SERVICE BULLETIN

Classification: BT17-009	Reference: NTB17-074	Date: July 10, 2017
-----------------------------	-------------------------	------------------------

2016-2017 MAXIMA; RUST AROUND REAR LICENSE LAMP FINISHER

APPLIED VEHICLE: 2016-2017 Maxima (A36)

Figure 1

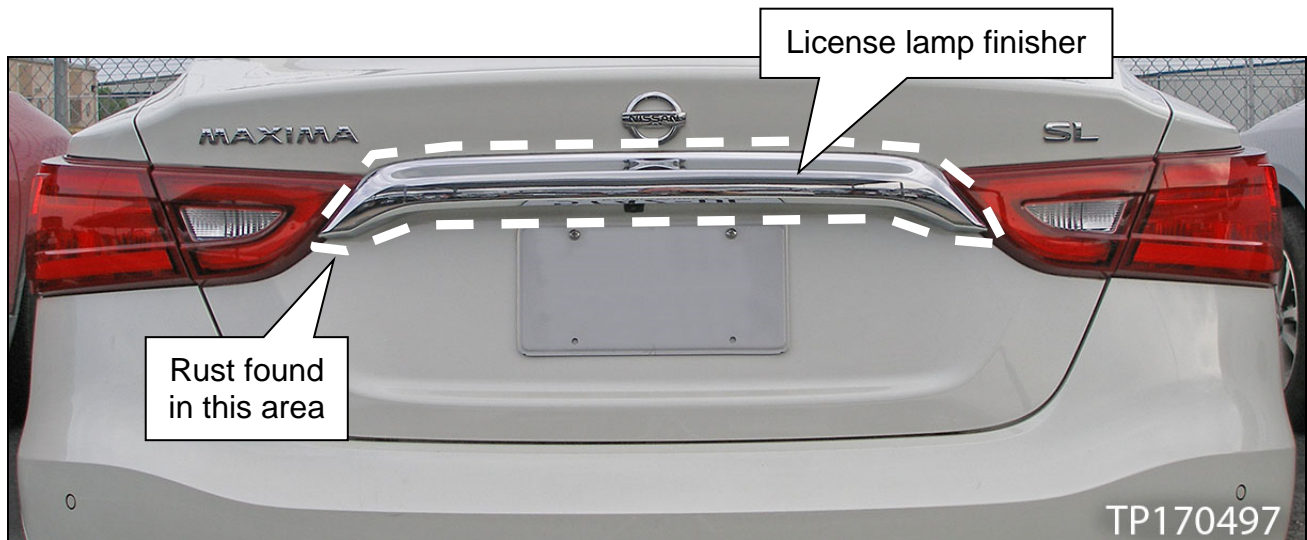
When rust is found on the rear deck lid surface in the area surrounding the license lamp finisher (Figure 1), or when replacing the license lamp finisher for any reason.

- Replace the license lamp finisher with the new replacement part listed in **PARTS INFORMATION**.
 - Refer to the Electronic Service Manual (ESM), section **EXT – Exterior**, for removal and installation information.
- Repair any damaged surfaces that were in direct contact with the license lamp finisher.
